Subject: Arkansas Nuclear One - Unit 2
Docket No. 50-368
License No. NPF-6
Containment Cooling Response Time Technical Specification Change Request -
Additional Information (TAC No. M92066)

RESPONSE TO NRC QUESTIONS

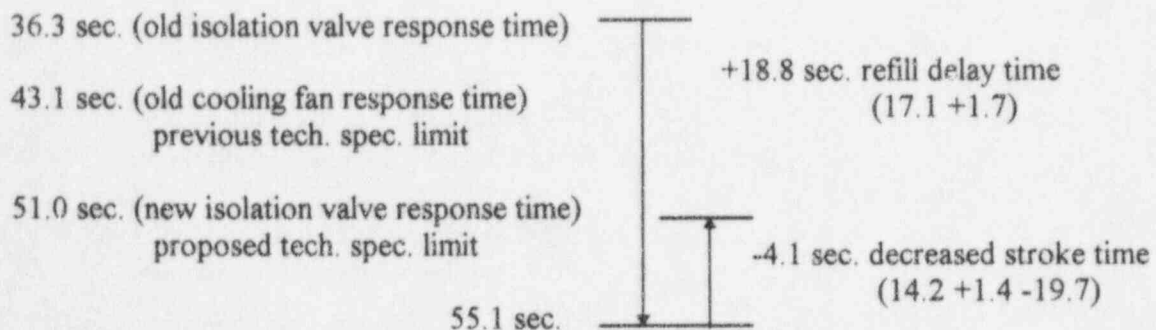
3. The licensee's analysis uses 17.1 seconds for the delay time to maintain the containment cooling service water valves closed until the service water pumps start and the slow refill has occurred, and the delay time for 10% opening of the containment cooling service water inlet valve and full opening of the outlet valve are 1.4 seconds and 14.2 seconds, respectively. The staff requires additional explanation of specifically how these delay times were arrived at. Explain why the additional 17.1 second delay time only results in an overall change of 7.9 seconds in the TS requirement. For comparison, the staff also requires a breakdown of the delay times associated with the 28.1 seconds that is referenced for the case when off-site power is available.

Based on the isolation valve as the limiting component, the system response time without offsite power available contains the following individual component times:

1.6 sec.	ESFAS instrument response time
15.0 sec.	Emergency diesel start time
17.1 sec.	Delay time for refilling the service water piping Total delay time for refilling is the sum of the SW pump sequencing time plus 10% tolerance on the sequencing time(6.0 sec. + 0.6 sec.) and the refilling time (10.5 sec.) (6.0 sec. + 0.6 sec. + 10.5 sec. = 17.1 sec.)
1.7 sec.	Uncertainty in total refill time (10% of 17.1 sec.)
14.2 sec.	Inlet and outlet valve stroke time
1.4 sec.	Delay before outlet valve begins to open (10% of inlet valve stroke time) Total valve stroke time (14.2 sec. + 1.4 sec. = 15.6 sec.)
51.0 sec.	Total response time
